Sewerage & Water Board of NEW ORLEANS

Addendum No. 4

Your reference is directed to **Contract 1415 – CARROLLTON WATER PURIFICATION PLANT WEST POWER COMPLEX FOUNDATIONS AND UNDERGROUND UTILITIES** for the Sewerage and Water Board of New Orleans which is scheduled to open at **11:30 a.m. Local time on February 8, 2023.**

Questions and Responses During Bidding

A/E DWG NO.: M4-1-1

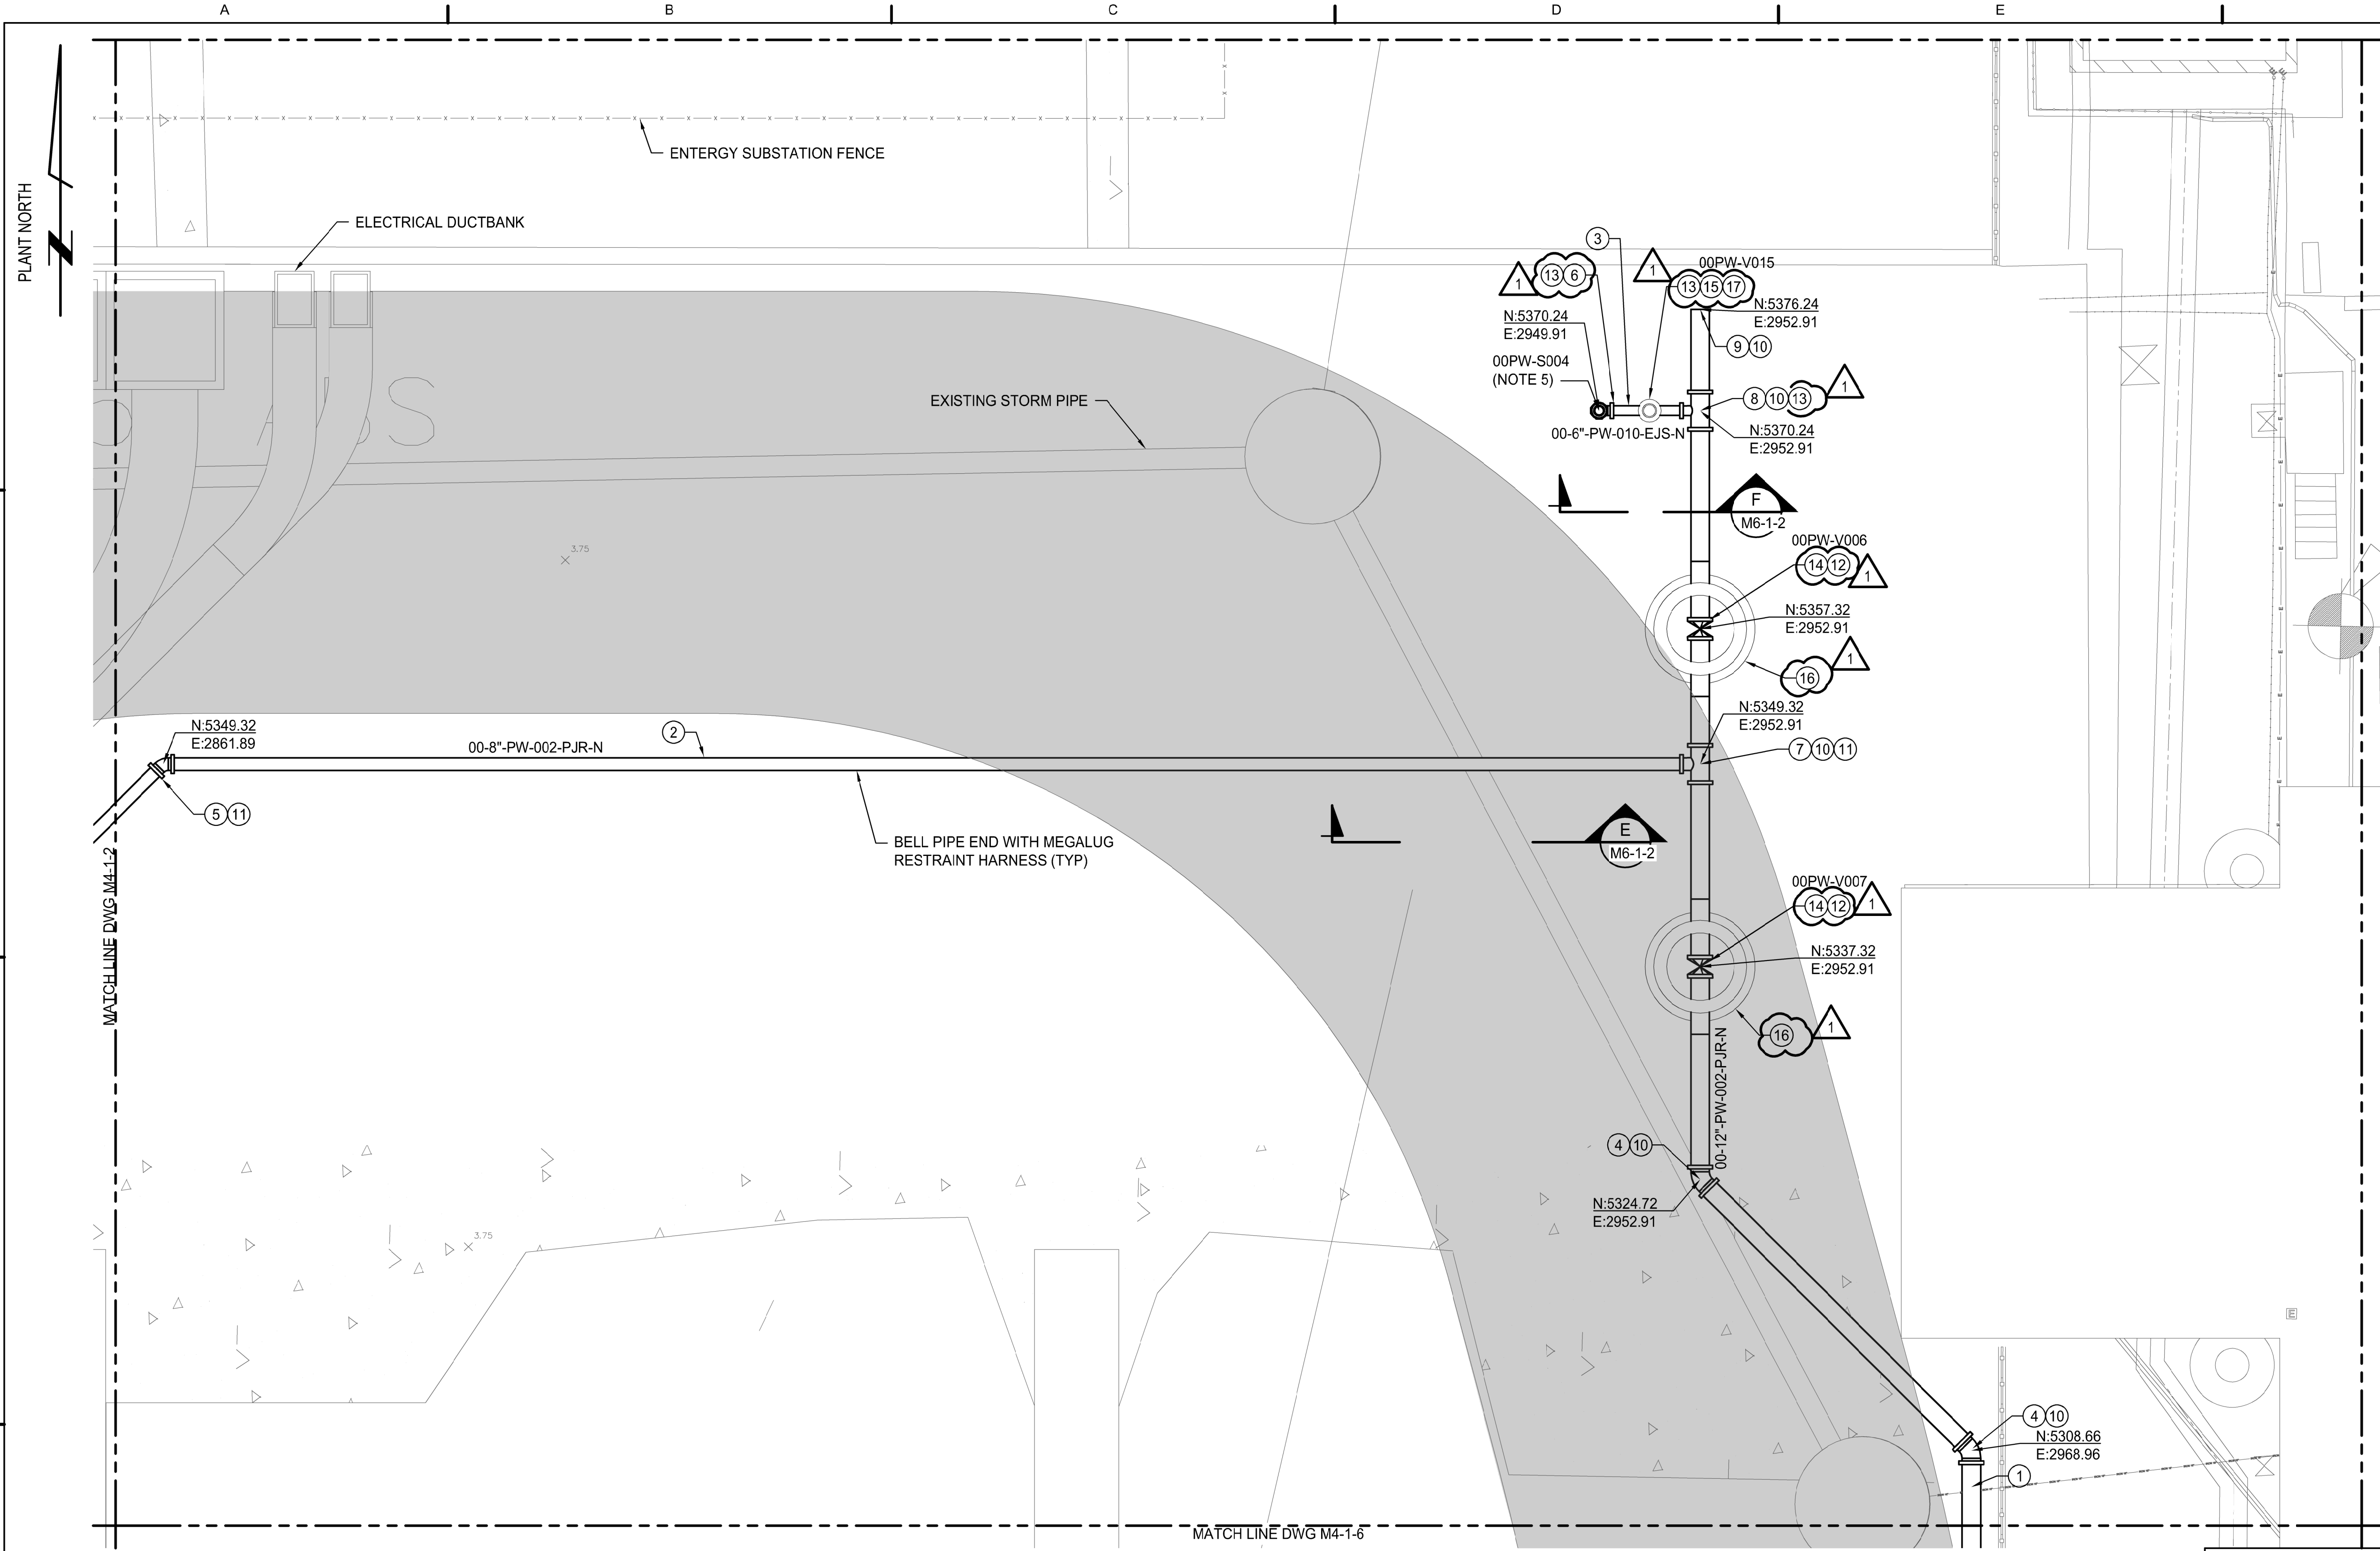
RESPONSE #29	The Operations Center subgrade will be 1'-0".
BIDDER QUESTION #30	Drawings M4-1-1 through M4-1-19 note "BELL PIPE END WITH RESTRAINT HARNESS (TYP)". Detail 4 on DWG M6-2-4 shows the typical connection for the C900 bell and spigot end with the restrainer. Are all bell and spigot joints to receive a pipe-to-pipe restrainer?

RESPONSE #30	Piping within C7 plan does not include long straight runs. Due to many fittings involved and lack of support for thrust blocks, all bell and spigot joints shall include restraint.
BIDDER QUESTION #31	Drawings M4-1-1, M4-1-3, M4-1-5, M4-1-6, M4-1-9, M4-1-12, M4-1-13, M4-1-15, and M4-1-17 note that the Water Valve Manholes shall be as per S&WB DWG No. 6179-F-2. The notes pointing to the valves within the manholes call out "Restrained Joints, PVC, Megalug 2000PV or Equal". S&WB DWG No. 6179-F-2 depicts Ductile Iron piping entering and existing the water valve manholes. Please confirm that the restrained joints within all new water valves manholes will require Ductile Iron piping as per the S&WB detail.

RESPONSE #31	The restrained joints within water valve manholes will require DI piping as shown on S&WB detail. The drawings contained in this question have been revised to remove reference to PVC restraint at valve manholes, and are included as part of this Addendum 4.
BIDDER QUESTION #32	Can you please confirm that the steel beams, posts, columns, grating, and any other structural steel member (other than concrete/masonry embeds i.e., base plates and anchor bolts) are not included in this contract. The Structural Drawings note that Elevated Platforms and Stairs will be in future contracts 1416 & 1420.
